L-QTS-84-009

10CFR21 COMMITTEE MEETING HELD MAY 16, 1984

A control panel bracket support welded to the diesel lube oil cooler has developed cracks in the weld and resulted in a small lube oil cooler leak.

PSD DOCUMENT NO. 10CFR21-0018-003

FIG 1

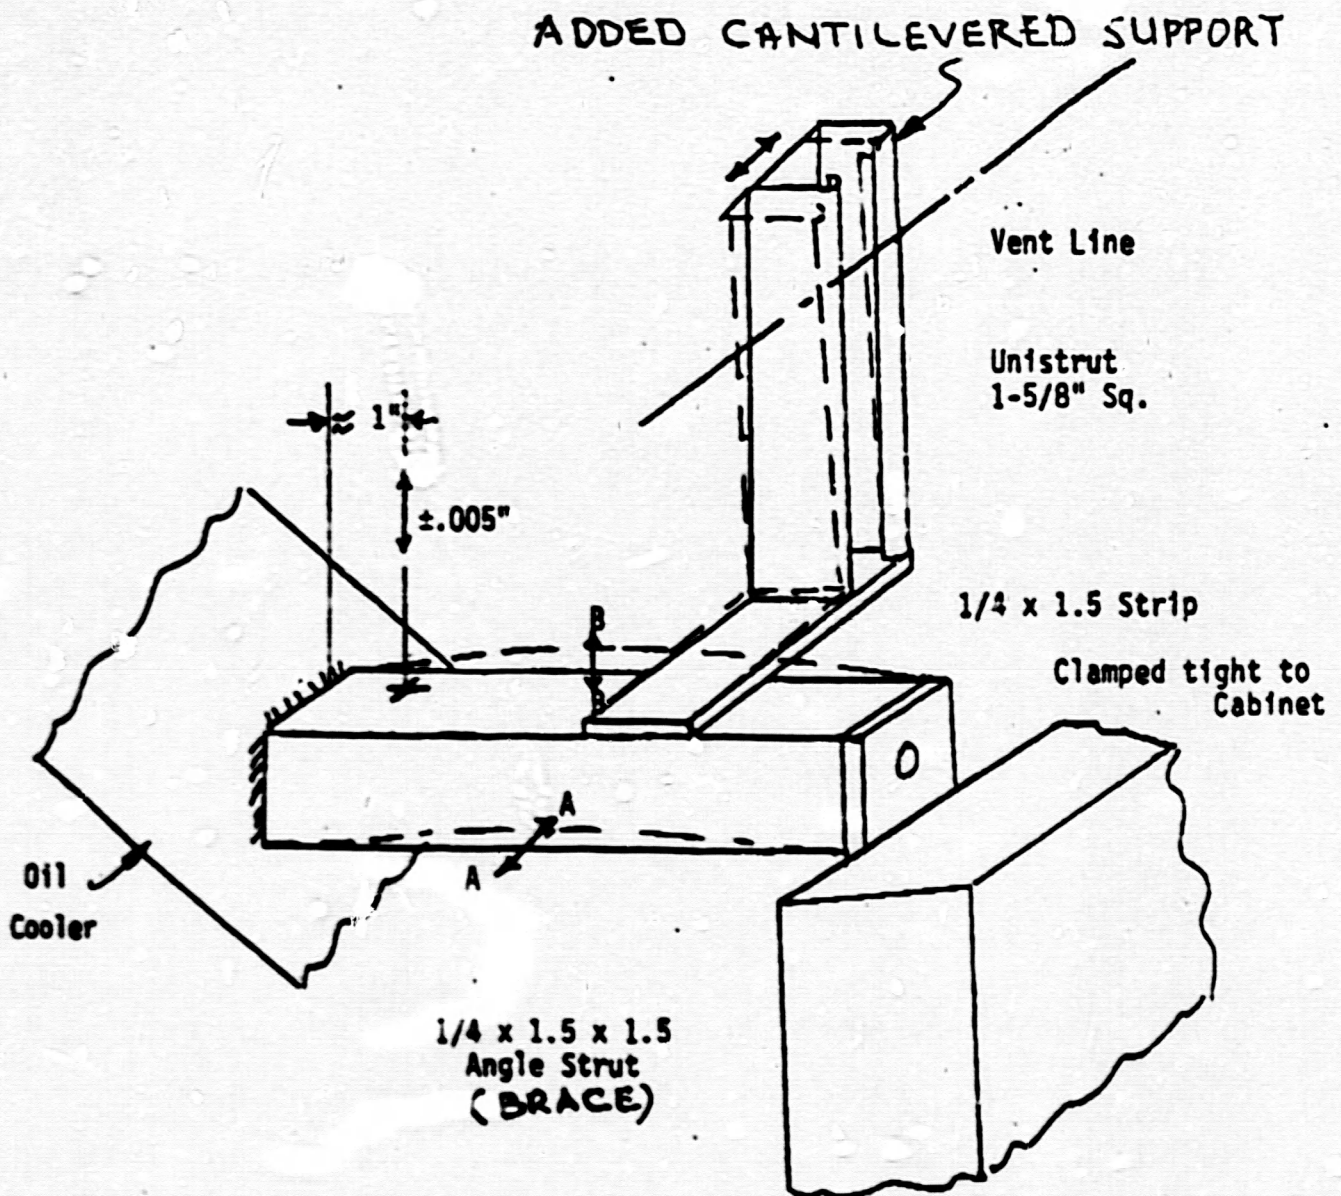
- DISCUSSION:
- 1) Power Systems issued a 10CFR21 Report #10CFR21-0018, based upon initial information furnished by the Owner.
 - 2) Subsequently, it was discovered that a cantilevered structure (FIG. 1) had been added recently to the brace to support newly added vent piping for the diesel engine lube oil system.
 - 3) A site investigation was initiated jointly by the Owner and Power Systems to determine the actual cause of the defect.
 - 4) The result of this investigation is contained in Flight Dynamics, Inc. Report A-10-84.

The report shows, by calculation, that the stresses at the brace and lube oil cooler junction are low as it was originally installed. However, the addition of the cantilevered support introduced high cyclic stresses in cases where the added support structure was close to the 3d harmonic (45 Hz) of diesel speed (900 RPM/15 Hz) as indicated on Table II. Note, those with considerable higher natural frequencies showed no weld distress.

- 5) The conclusion that the added cantilevered supports are the cause of failure is supported by the fact that the joint between the lube oil cooler and the angle brace showed no distress after approximately 200 hours of engine operation but showed distress within a few hours of operation following the addition of the support.

FIGURE 2

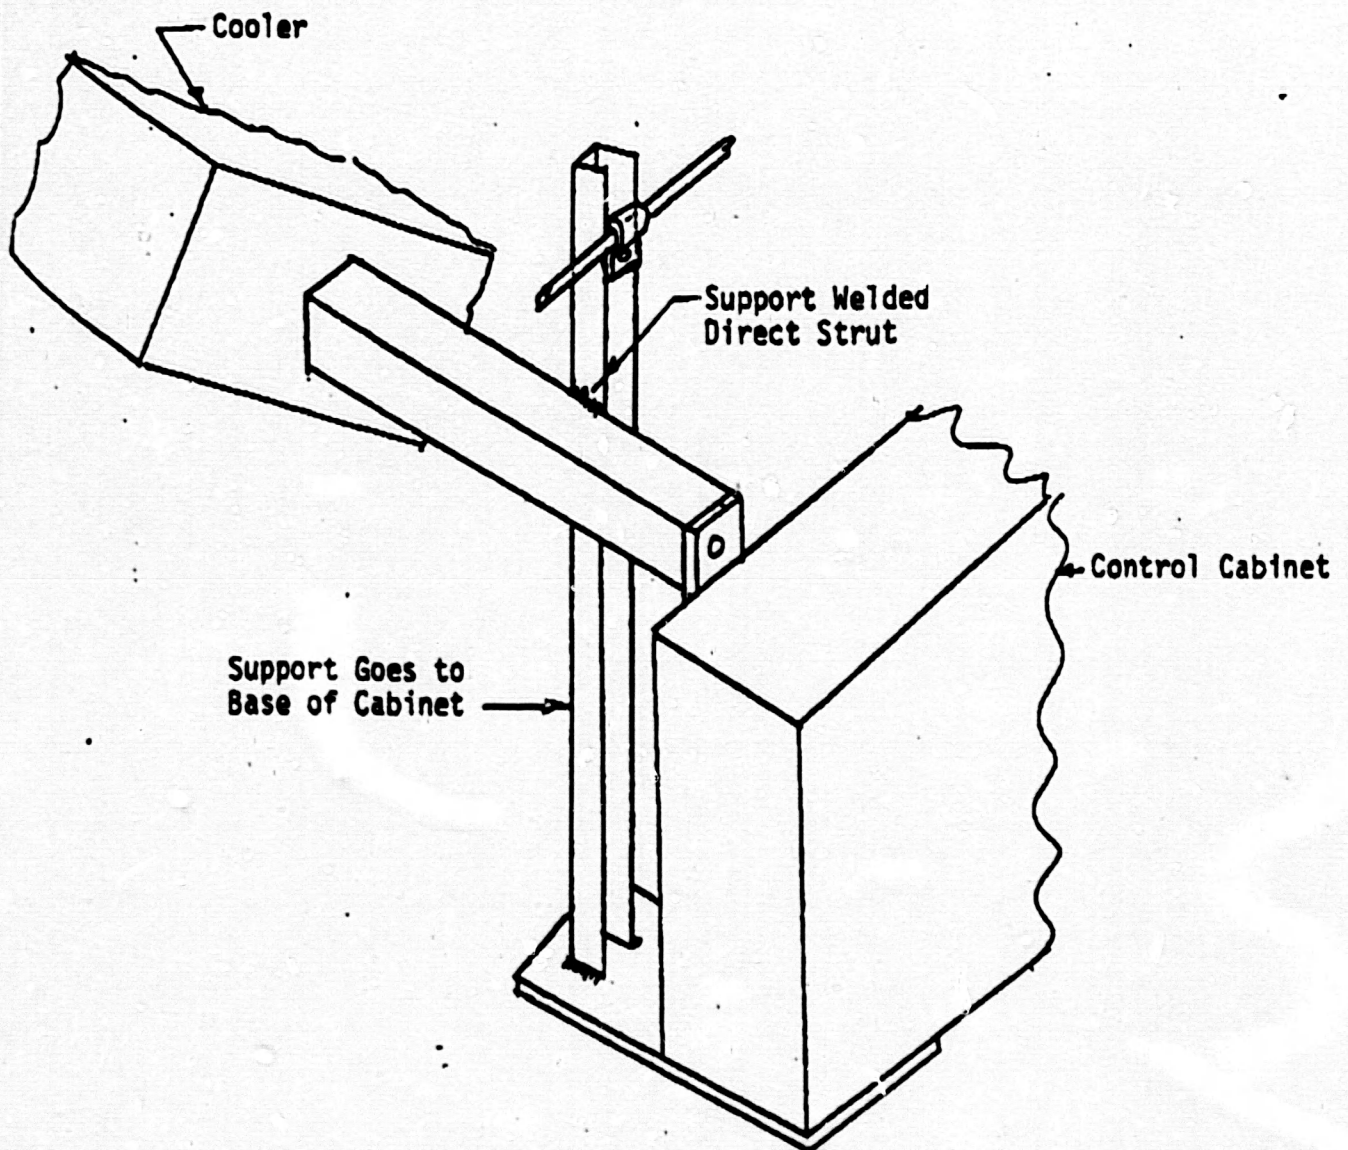
The corrective action taken at the site was to remove the cantilever type support and install a support that is to be connected down to the skid base as shown in Figure 2.

DIAGRAM SHOWING STIFFENED SUPPORT FOR
COOLER VENT PIPE
